BRUNSWICK STEAM ELECTRIC PLANT, UNIT NO. 1
DOCKET NO. 50-325/LICENSE NO. DPR-71
SUPPLEMENT TO REQUEST FOR LICENSE AMENDMENT (TSC 00TSC06)
INSERTION SURVEILLANCE OF CONTROL ROD 26-47
RESPONSE TO REQUEST FOR ADDITIONAL INFORMATION

BRUNSWICK STEAM ELECTRIC PLANT, UNIT NO. 1
DOCKET NO. 50-325/LICENSE NO. DPR-71
SUPPLEMENT TO REQUEST FOR LICENSE AMENDMENT
INSERTION SURVEILLANCE OF CONTROL ROD 26-47

RESPONSE TO REQUEST FOR ADDITIONAL INFORMATION

Figure 1
Control Rod Drive Mechanism (Withdraw Mode)

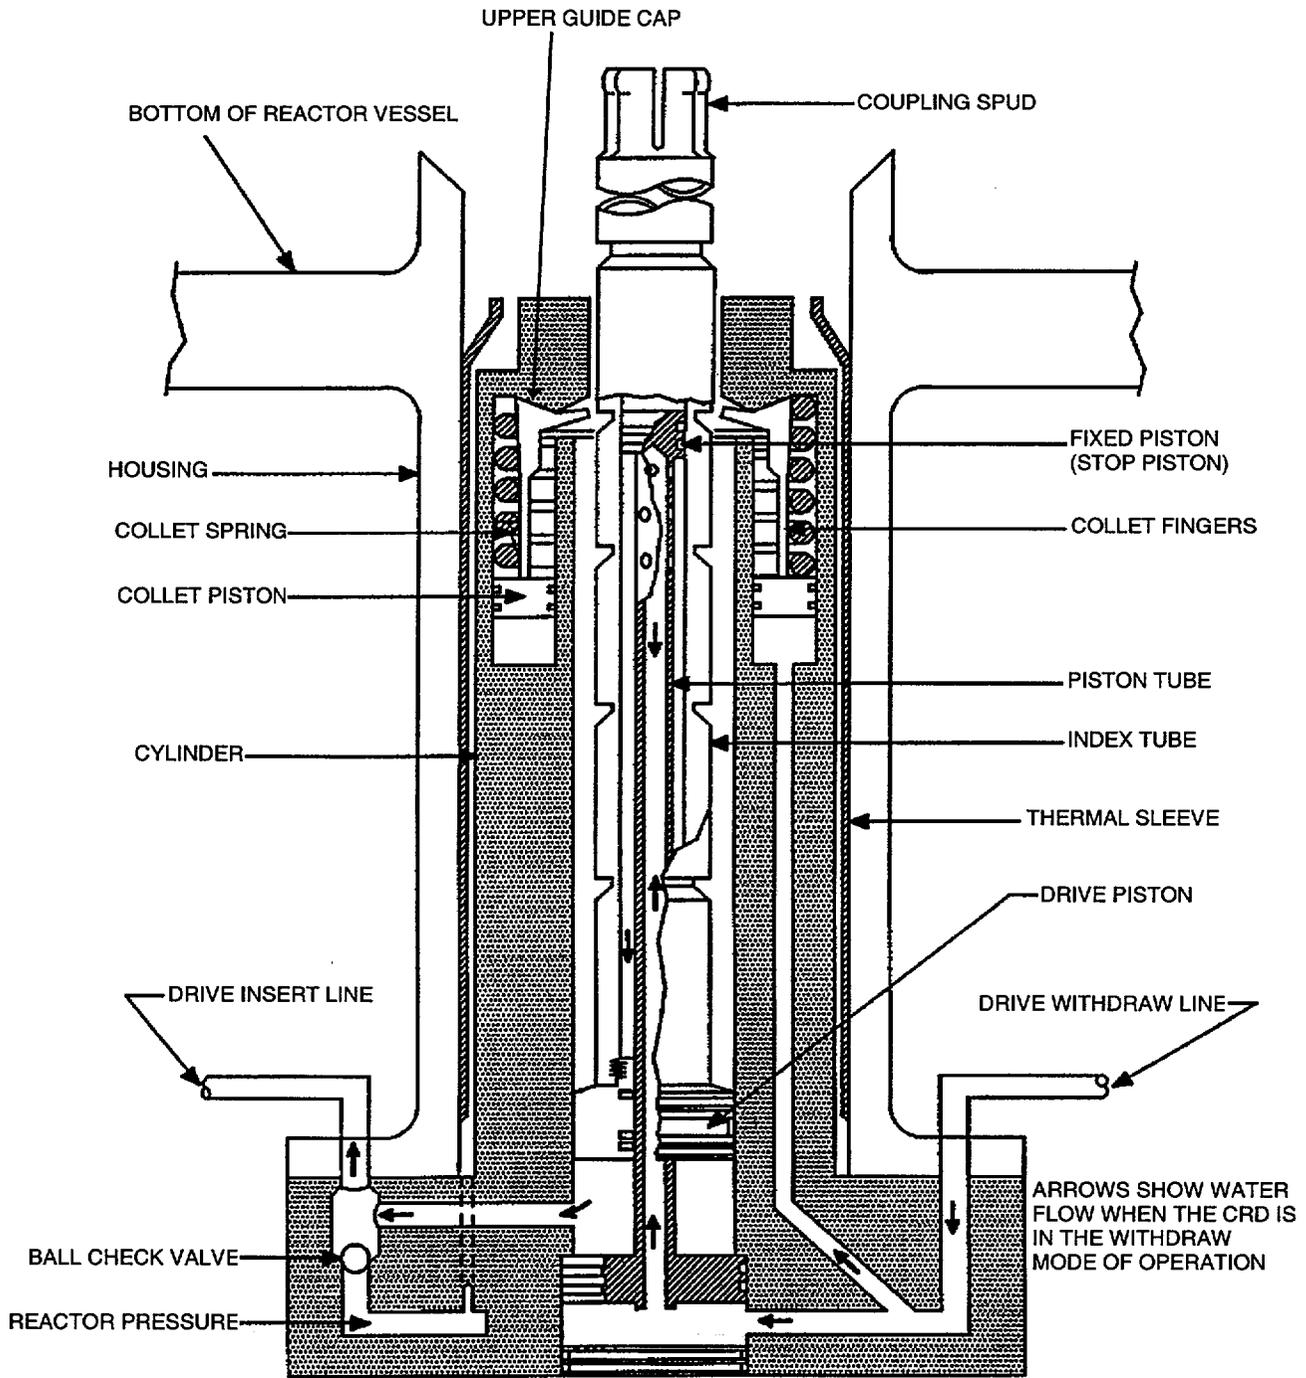
Please provide additional information supporting the conclusion that control rod 26-47 remains capable of inserting.

The collet fingers are normally cammed out of the way to allow rod withdrawal by moving the collet piston upward and allowing the fingers to cam into the upper guide cap (i.e., see Figure 1). The weight of the control rod blade and the index tube is approximately 280 pounds. The resulting friction between the index tube notch and the collet fingers is too great to permit the pressure force from the collet piston to extend the fingers. Therefore, in order to withdraw the control rod drive, the weight on the collet fingers must first be overcome. This is accomplished by first inserting the index tube a small distance (i.e., approximately 1 to 3 inches), prior to applying a withdraw signal. The withdraw signal then cams the collet fingers out due to the tapered surface of the upper guide cap. Water from the drive water header is then applied above the main drive piston. This water also actuates the collet piston, pushing it up, opposing the collet spring pressure. A pressure of 180 psi above reactor pressure is needed to counteract the collet spring pressure of 150 psi and maintain the collet fingers out of the way for the withdraw cycle.
